SERVICE BULLETIN

SERVICE BULLETIN NUMBER: 08-25-08-1

APPLICATION: Fuel Gasculator

SUBJECT: Gasculator Safety wire.

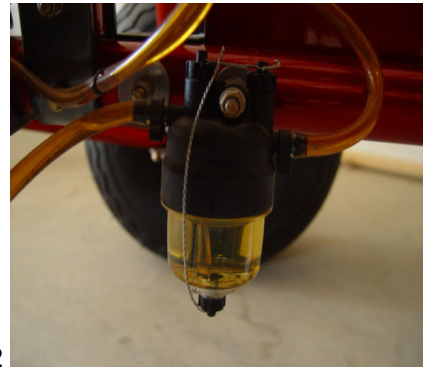
Powrachute, LLC just recently received notification of a Gasculator lower plug coming loose due to vibration. This will cause the fuel to drain out of the Gasculator bowl and starve the engine of fuel.

Make sure Bowl and all three plugs are tight.

Drill 1/16" hole in the 1/4" stem part of the plugs. Safety wire the two top vent plugs to each other (See picture #1 below).

Drill 1/16" hole in the 1/4" stem part of the bottom plug. Safety wire the bottom plug to the safety wire connecting the two top plugs. (See picture #2 below)
